Groundwater Application Review Summary Form

Application # G- 18494

PUBLIC INTEREST REVIEW FOR GROUNDWATER APPLICATIONS

TO: Water Rights Section Date 4/9/2018
 FROM: Groundwater Section Jen Woody
 Reviewer's Name
 SUBJECT: Application G- 18494 Supersedes review of n/a
 Date of Review(s)

Figure 3. Water-Level Trends in Nearby Wells

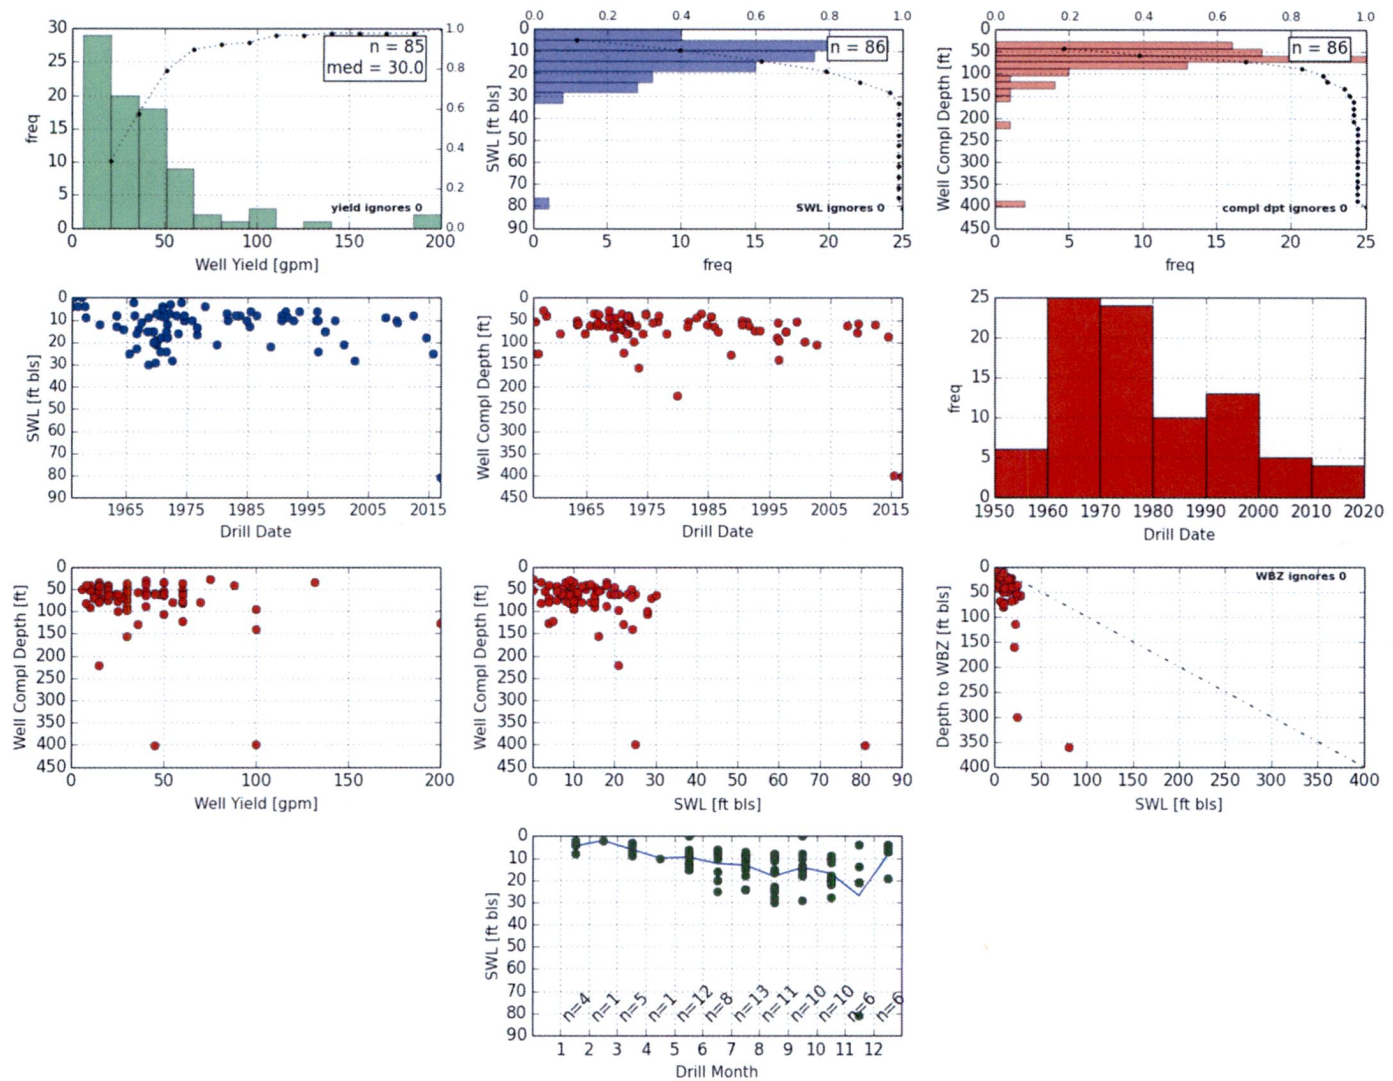
OWRD has SWL data from an observation well nearby (BENT 1558), which is on the other side of the river. These data show generally stable trends over the past three decades but lack of sufficient groundwater level data on the applicant's side of the river make it difficult to establish groundwater over-appropriation. Given the lack of nearby groundwater level data for the bedrock aquifer, water level monitoring and reporting conditions are recommended.
